PRAIRIE ISLAND NUCLEAR POWER PLANT

MASONRY WALLS - IE BULLETIN 80-11

RESPONSE TO REQUEST FOR ADDITIONAL INFORMATION

SEPTEMBER 1982

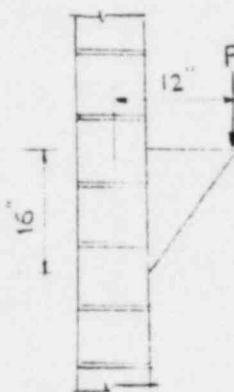
Provide sample calculations for block pullout analysis.

In case of Prairie Island Nuclear Plant no major pipe thrust or other heavy loads are attached on any of the safety related masonry wall. Typical attachment weighs well below 100 lbs.

Sample calculations for block pullout analysis is provided below:

Given $I = 400$ lbs.

Seismic forces: Vertical = 500 lbs.

Horizontal = 600 lbs.

Horizontal load on block A due to eccentricity

$$= 400 \times 12/16 = 300 \text{ lbs.}$$

Therefore, Total Horz. load on block

$$A = 600 + 300$$

$$= 900 \text{ lbs.}$$

For one hollow block, $7\text{-}5/8" \times 7\text{-}5/8" \times 15\text{-}5/8"$;

$$\text{end area (2 sides)} = 7\text{-}5/8" \times 7\text{-}5/8" \times 2 = 116 \text{ in}^2$$

$$\text{Top surface (Net)} = 15\text{-}5/8" \times 4.04 = 63 \text{ in}^2$$

$$\text{Bott. Surface (Net)} = 15\text{-}5/8" \times 4.04 = 63 \text{ in}^2$$

$$\text{Total Area} = 242 \text{ in}^2$$

$$\text{Allowable shear stress} = 0.9 \sqrt{F_m'} = 0.9 \sqrt{1350}$$

$$= 33 \text{ psi}$$

$$\text{Available Pullout resistance} = 33 \text{ psi} \times 242 \text{ in}^2$$

$$= 7,986 \text{ lbs.}$$

$$>> 900 \text{ lbs. O.K.}$$

SECT. A.A.

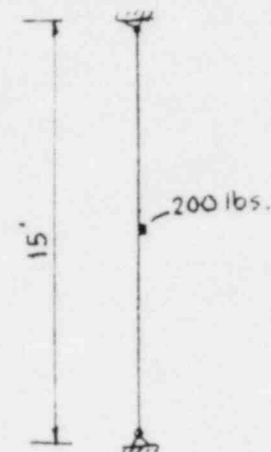
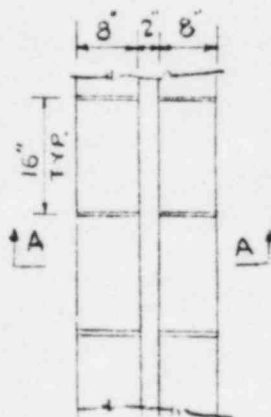
According to section 7.4.4.3, Attachment A of reference 3, a limit of 25 psi has been used for tension between wythes of multi-wythe walls in composite action. Justify this value by any existing test data. Also provide and justify by any existing test data the value for allowable collar joint shear stress. Provide sample calculations illustrating the analysis of multi-wythe walls in composite action.

Sample Calculation:

- Given: 18" Double Wythe solid grouted wall
- : Span = 15', both ends simply supported
- : Attached load on wall = 200 lb. rigidly attached

Assume: Wall is uncracked

Tension Between Wythes:

Frequency at Vibration as Simple Beam = 21.3 cps

Horizontal Floor Spectral Acceleration

due to operating basis earthquake

$$= 0.094 \text{ g}$$

Horizontal Force due to attachment

$$= .094 \times 200 = 19 \text{ lbs.}$$

Tension between Wythes due to

Attachment (assume one block area)

$$= 19 / (16 \times 8) = 0.15 \text{ psi}$$

Transverse seismic loads on wall

$$= .094 \times 150 \times 18/12 = 21.4 \text{ lbs/sft}$$

Tensile stress (between wythes)

$$= 21.4/2 \times 144 = .07 \text{ psi}$$

Total tensile stress = .07 + 0.15 = 0.22 psi

Collar Joint Shear Stress:

$$\text{Shear } V = (21.4 \times 15/2 + 19) = 180 \text{ lbs.}$$

$$I/Q = 1/12 \times 18^3 / (8 \times 8/2) = 15.2$$

$$\text{Shear stress} = \frac{VQ}{Ib} = \frac{180}{15.2 \times 12} = 1 \text{ psi}$$

$$\text{Shear stress (SSE)} = 2 \text{ psi}$$
